Consultation on Euston Area Plan – Regulation 19

RE: Consultation on Euston Area Plan – Regulation 19

Annex 1: Specific suggested edits and comments from TfL on the draft Euston Area Plan update

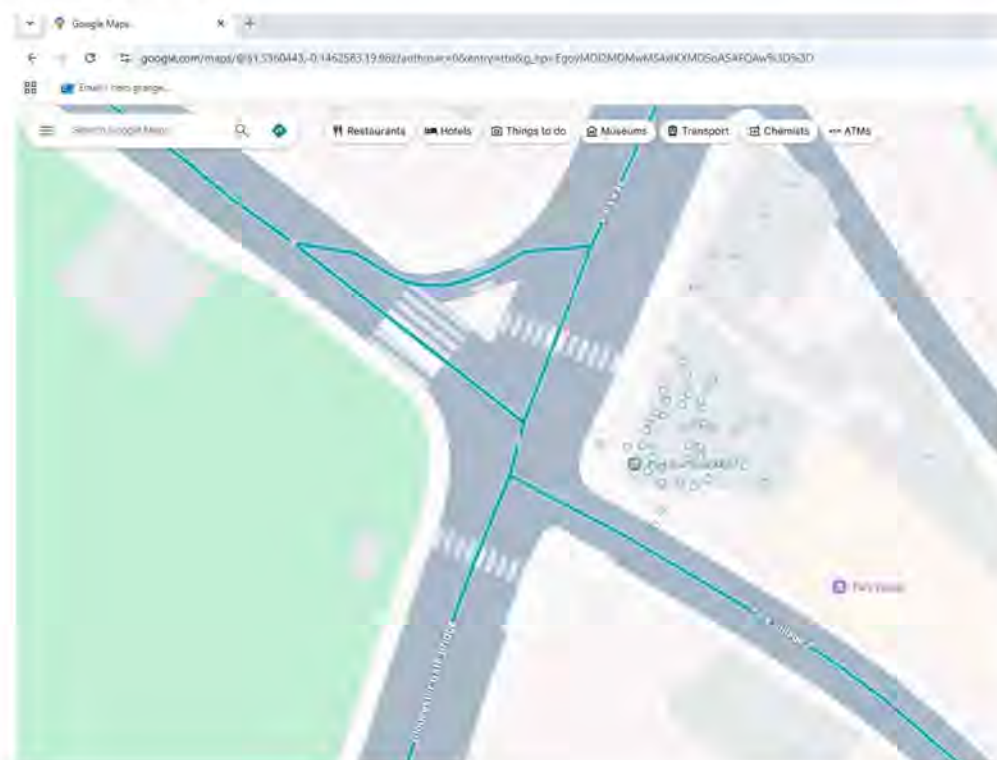
There also seem to be problems with the format of the EAP document itself. I noted that the heading at top left of the pages did not concur with the relevant section of the document. Also, in the form, the question whether the document 'Complies with the duty to co-' is left hanging like this without the necessary 'operate'.

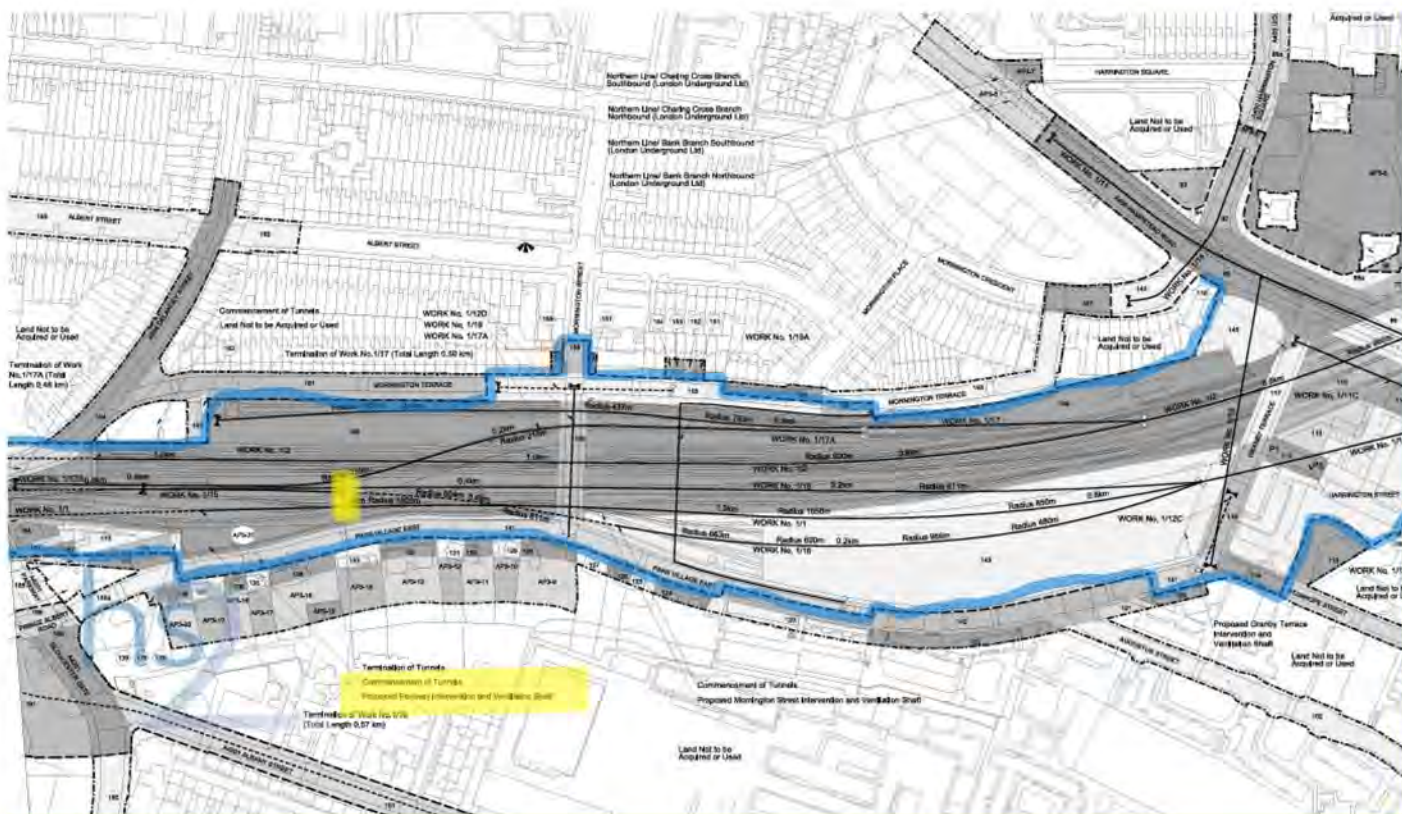
Please also note that whoever has drawn up the map on p. 165 has mistakenly written 'Gloucester Gate' at the top of the area defined – in fact, Parkway extends as far as Park Village East. (The road between Park Village East and Albany Street is Gloucester Gate Bridge with Gloucester Gate proper beginning beyond Albany Street>)

There is also an error on the map where the southern part of Park Village East is bordered by green dots, these dots apparently indicating 'existing roads within Euston Healthy Streets proje[ct]'. In fact, none of Park Village East is a so-called Healthy Street. On the contrary, it is an official HS2 lorry route. (Meanwhile the Arlington Road Healthy Streets Area prevents us driving to anywhere to the east of us.)
